WEBSTER ISB
TYPE
SA-1255

Shop Drawing Submittal Review

Project Name: Webster University-**ISB**

Copies	No.	Description
1 PDF	265100E02	(Submittal No. 265100-005) – Indoor Lighting (& Outdoor Lighting)
		• EB, EK, RQ, & SA

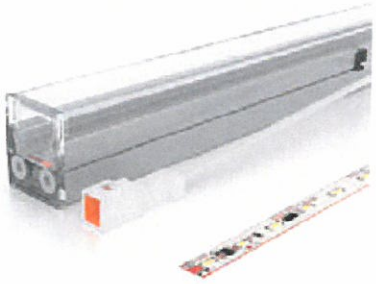
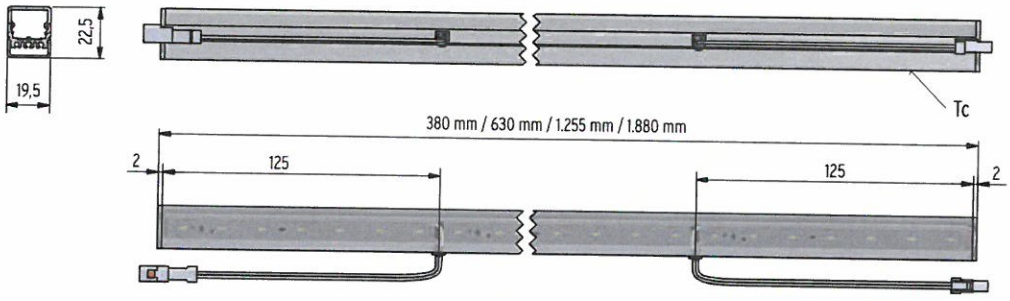
1. Coordinate all color finishes with architect.
2. Type EB: Provide W825 configuration. Coordinate and conceal wiring within guardrail to remote drivers. Provide 45 degree mounting clips. Contractor shall ensure fixtures are securely fastened to guardrail.
3. Type EK – Revise and Resubmit "D3" series in-lieu of "D4" series. This fixture is intended to aim downwards and be equipped with a lens to diffuse the view into the fixture.
4. Type RQ – Coordinate installation with existing fixtures.
5. Type SA – Revise and Resubmit. Submit Hydra LD25 linear product in-lieu of Xooline pre-configured product submitted.
